aLIGO PSL PMC D1001955-v1 assembly drawings

Patrick Kwee (patrick.kwee@aei.mpg.de), Jan Pöld (jan.poeld@aei.mpg.de)

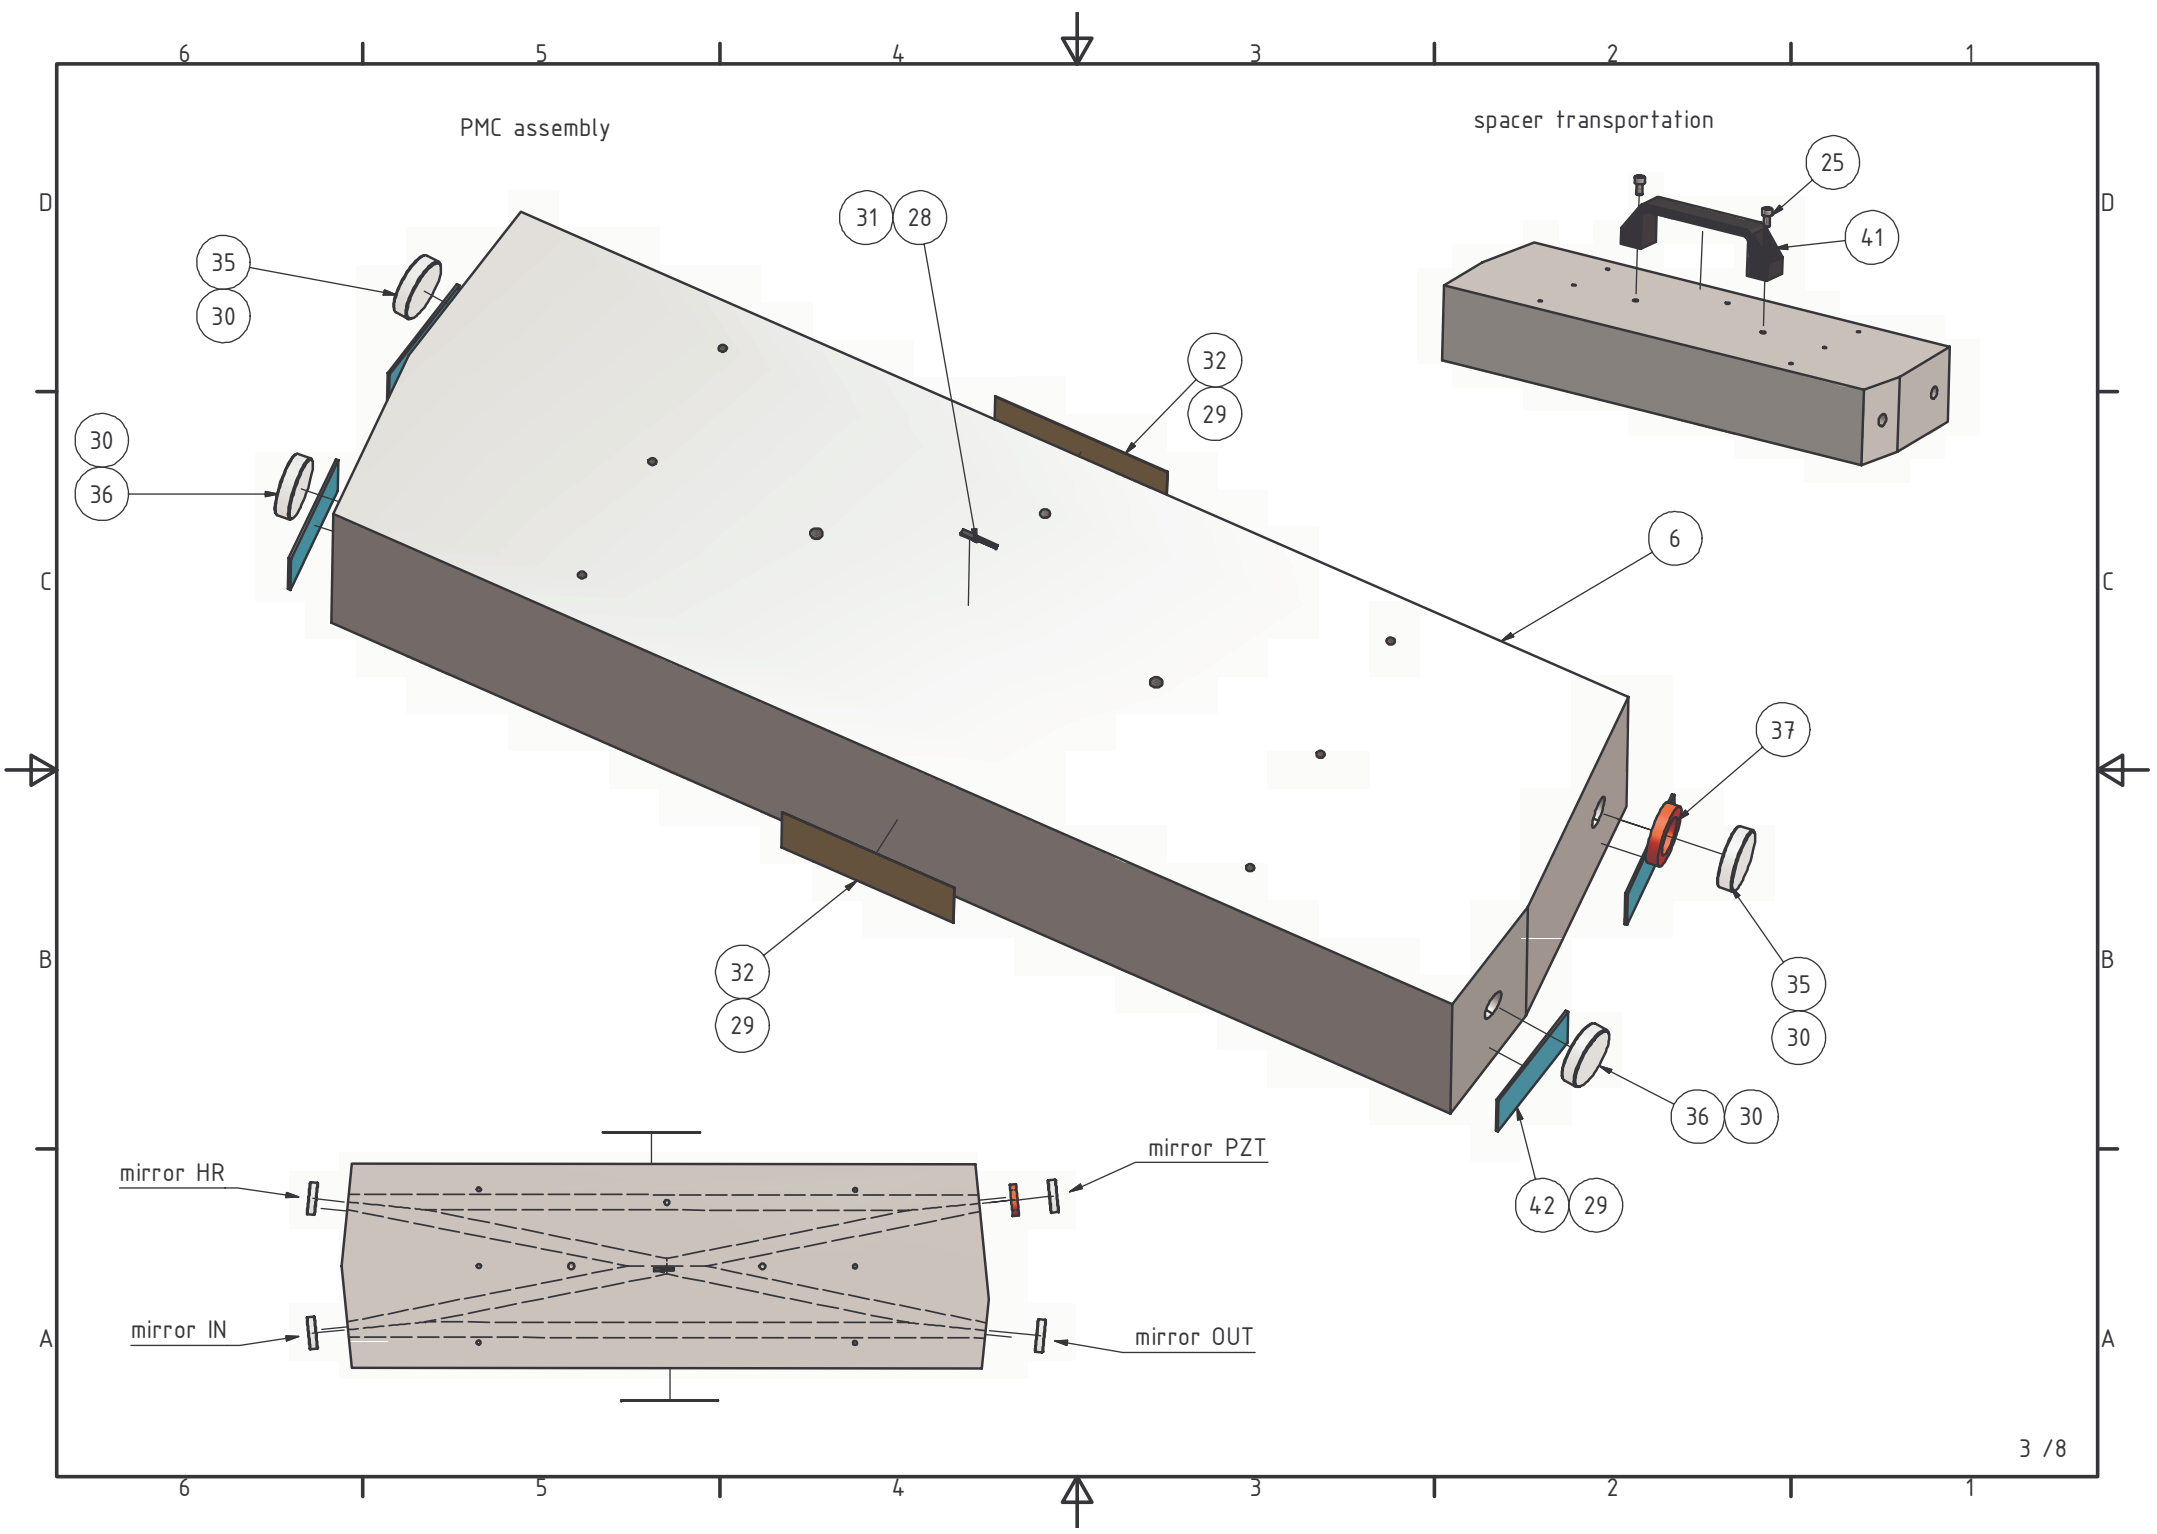
Part "cover-2" (assembly item #9) is not to be included so that outgassing from the assembly does not deposit on the windows and cause a degradation in throughput over time (B. Willke, 10 June 2013, see E1300284-v1)
